2/5/2026

Bike Anchorage Comment Re:
Safer Seward Highway Draft Environmental Assessment

Figure 2-2. Fatal crash locations (2017–2021).

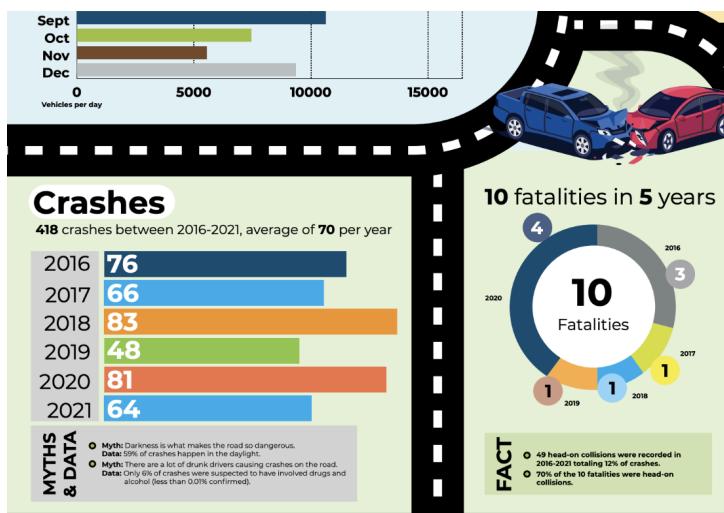
There is a serious issue with the crash data in Appendix G. The document states: "Four crashes within the Project corridor resulted in fatalities during the 5-year study period: two in 2018, one in 2019, and one in 2021 (Figure 2-2). Three of the fatalities were from head-on crashes that occurred between MPs 102 and 104." Figure 2-2 plots these on a map and immediately contradicts the narrative, with four crashes listed with the dates 2018, 2019, 2020 and 2020.

For the purposes of our analysis in this document, we have assumed that the only error in this graphic is in the year listed for each crash, and that the other characteristics attributed to each crash are accurate. However, as you can imagine, the quality of the data provided by the project team constrains our analysis here as much as it determines the validity of the EA itself.

Figure 2-1. Crashes per year (2017–2021).

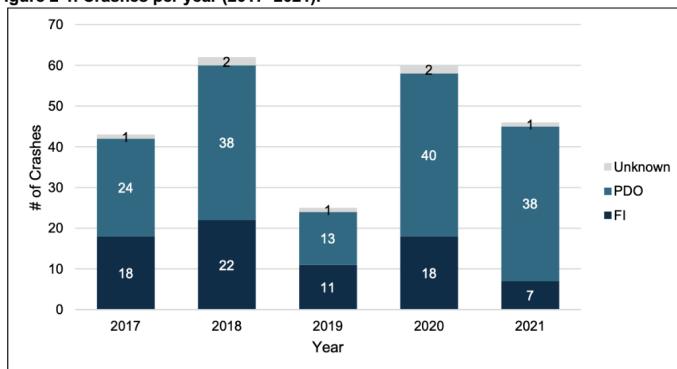
Finally, the draft EA makes clear that the data set is from 2017-2021, and presents a yearly breakdown of crashes that do not match up with those reported in the 2023 public presentation:

The 2023 slide deck claims an "average" of 70 crashes per year, but not a single year actually reported in the draft EA reaches that threshold. Which numbers are true and correct, and why were the others allowed to be released to the public?
